**Re: *The Woods at Viewcrest* · August 7, 2023 Request for Information (RFI)**

Re: Public Comment letter from *Protect Mud Bay Cliffs*  
- The Woods at Viewcrest subdivision proposal  
- Applicant's 12/5/23 response to the 8/7/23 Request for Information (RFI)  
- Is the Woods at Viewcrest Wetland Delineation Fundamentally Flawed?

Re: ***The Woods at Viewcrest*** subdivision proposal  
**Applicant's 12/5/23 response to the 8/7/23 Request for Information (RFI)**  
➤ ***Is the Woods at Viewcrest Wetland Delineation Fundamentally Flawed?***

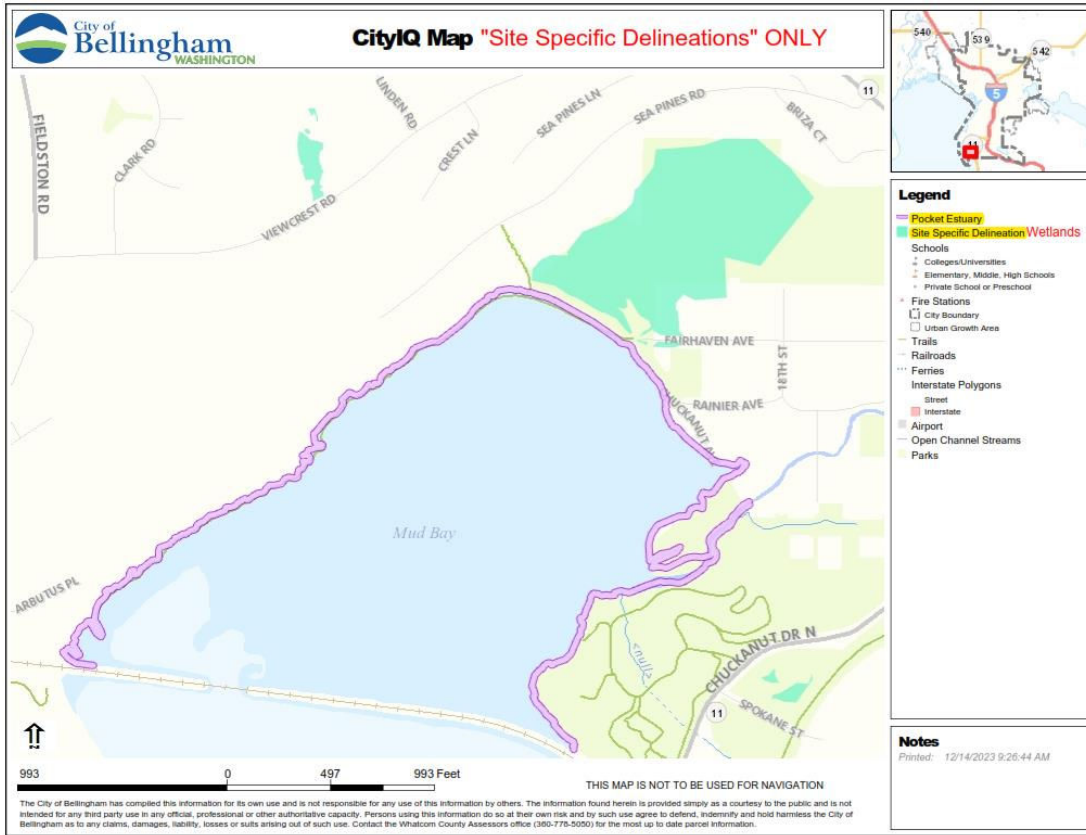
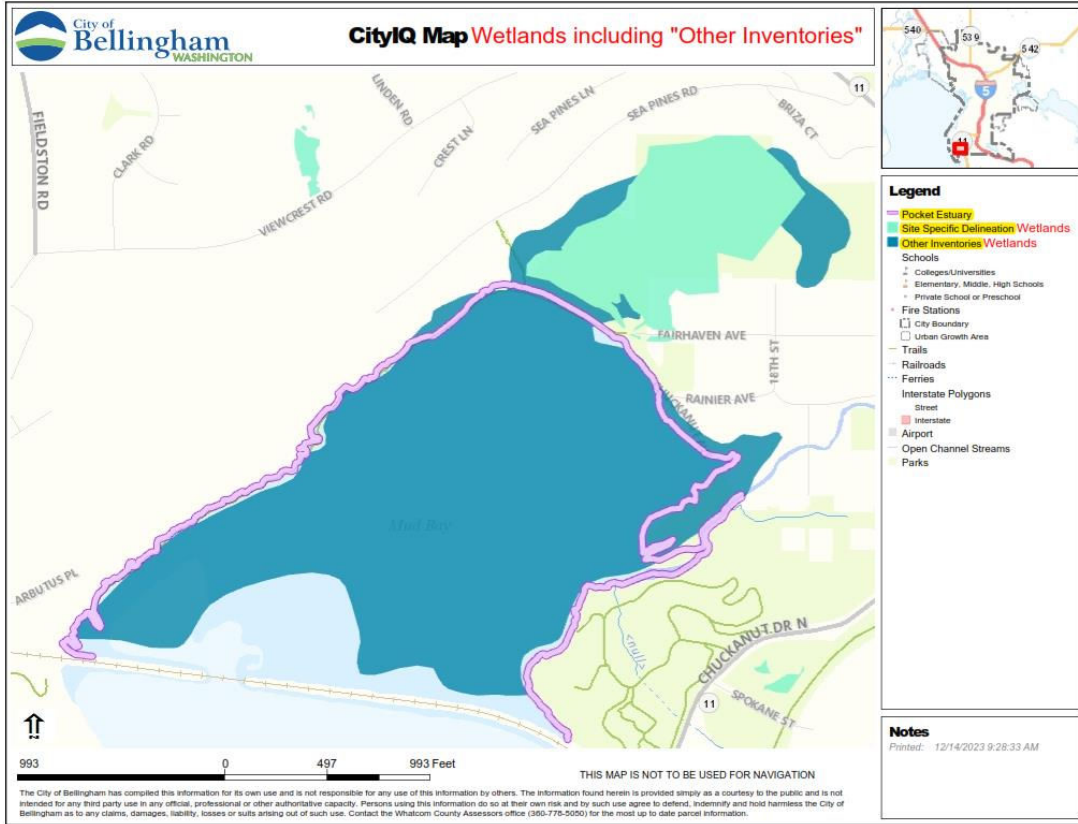
Although the City of Bellingham’s own CityIQ maps show Mud Bay as being distinct from Chuckanut Bay, the delineation refers to Mud Bay as Chuckanut Bay.

The NES wetland delineation recognizes the existence of estuarine wetlands throughout the entirety of Mud Bay (referred to as Chuckanut Bay) as identified by the USFWS NWI mapper. However, the delineation only considers a single “field-verified” estuarine wetland based solely on a CityIQ map, which includes only the *Site Specific Delineation* wetland layer. A more complete CityIQ map, which also includes the *Other Inventories* wetland layer, shows a solid zone of wetlands covering the vast majority of Mud Bay.

There is no indication that the NES wetland delineation attempted to confirm whether Mud Bay’s wetlands that were not “field verified” are, in fact, estuarine wetlands. Nor does the delineation acknowledge that Ecology has placed estuarine wetlands in a separate category because they are not conducive to field verification and, therefore, would not be included on a map of site specific delineated (i.e. “field verified”) wetlands.
